**SUBDIVISION,
PLANNED UNIT DEVELOPMENT,
PLANNING APPROVAL, &
REZONING STAFF REPORT****Date: April 2, 2015****APPLICANT NAME**The First, A Nation Banking Association, Rich Campbell,
Mobile Market President**SUBDIVISION NAME**

Mobile Metal Scrap Place Subdivision

LOCATION6445 Todd Acres Drive
(East side of Todd Acres Drive, 2/10'± mile North of
Hamilton Boulevard)**CITY COUNCIL
DISTRICT**

Subdivision Approval to create two legal lots of record from three metes and bounds parcels; Planned Unit Development to allow multiple buildings on a single building site, Planning Approval to allow a junk yard in an I-2, Heavy Industry District, and Rezoning from I-1, Light Industry District to I-2, Heavy Industry District to allow the operation of a junk yard.

SITE PLAN

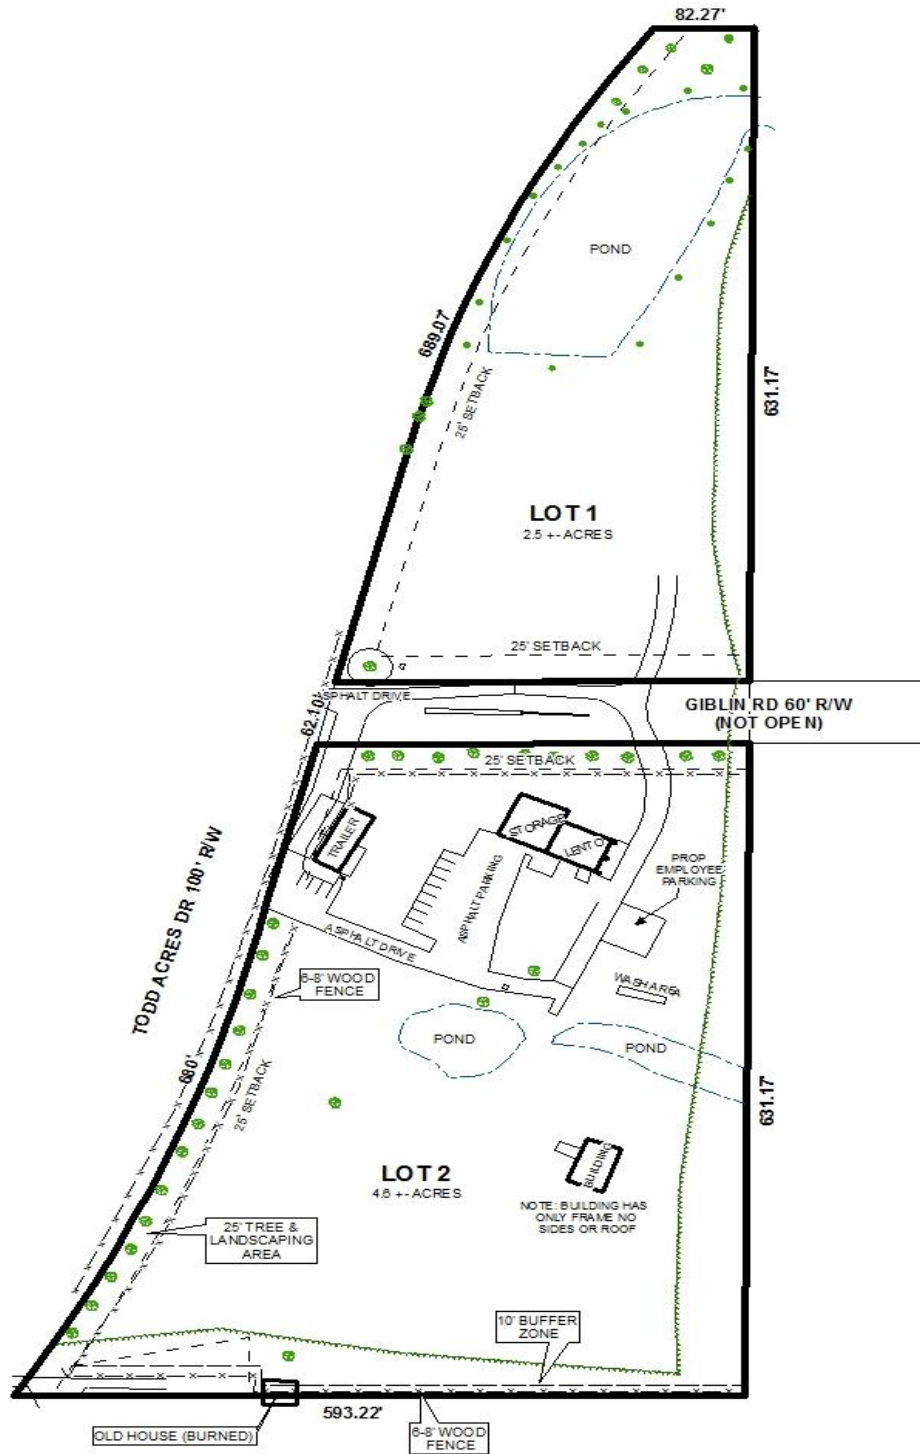
The proposed Lot 1 was cleared between 1997 and 2002 at the same time as the proposed Lot 2, prior to being annexed into the City of Mobile. There are no existing structures on the proposed Lot 1. Lot 2 has several existing structures including an office trailer, storage building with an attached lean-to, and a building which is described as the framing only of a structure with no roof or walls. Upon review of aerial photos, the structure described as not having a roof and walls, does in fact, appear to have a roof and walls. The applicant states no new building construction will occur at this time.

The site plan illustrates several trees to be placed along the frontages of Todd Acres Drive and Giblin Road, but does not illustrate full compliance with tree planting and landscaping requirements. The site should have 22 trees along Todd Acres Drive and 11 trees along Giblin Road. It should be noted that I-2, Heavy Industry District sites are required to provide full compliance with landscaped area requirements, but are only required to provide frontage trees.

Due to the nature of the proposed business, it is foreseeable that some of the structures will be used as a warehouse instead of an office; however no mention is made of the square footage that will be utilized for office space. The applicant does state that there will only be 3 full-time employees at the site. There are 12 parking spaces illustrated on an asphalt surface, and a new

It appears that the driveway connecting to an existing parking area is 18' wide, which is insufficient for two-way traffic. The site plan should be revised to illustrate a compliant 24' wide driveway.

A dumpster pad is illustrated on the site, but no mention of a dumpster enclosure is made. The site plan should be revised to illustrate a dumpster enclosure with sanitary sewer connection compliant with Section 64-4.D.9. of the Zoning Ordinance.

There is a note on the site plan that a 6-8 foot tall wooden privacy fence is to be placed along the North, West, and South of the site. It should be noted that a junkyard is required to be enclosed within an 8' high privacy fence, making it necessary to extend the fence along the East of the site. It should also be noted that the material stored on site cannot exceed the height of the privacy fence, per Zoning Ordinance requirements.

It appears that the property to the South of the site is used residentially, and the site plan illustrates a compliant 10' residential buffer in conjunction with the required 8' high privacy fence. Due to the nature of the proposed business, it may be appropriate to require a 25' vegetative buffer from the adjacent residentially used properties. The site plan illustrates an "old house site (burned)" straddling the South property line. Staff can find no demolition permits for the removal of the burned structure. The proposed 8' high privacy fence would bisect this structure. There is also an 18'± wide gravel road on the South of the site which appears to be used as access to the burned structure. It is unclear if this is an ingress/egress easement.

The proposed junk yard appears to be surfaced entirely with grass and dirt. The Zoning Ordinance requires at least aggregate surfacing, thus the site plan should be revised to illustrate concrete, asphalt, or aggregate surfacing.

The site plan illustrates that there is an existing fence with an asphalt driveway in the unopened right-of-way associated with Giblin Road. Per City of Mobile Engineering and Traffic Engineering comments, the private fence, gate, and any other structures should be removed from the right-of-way.
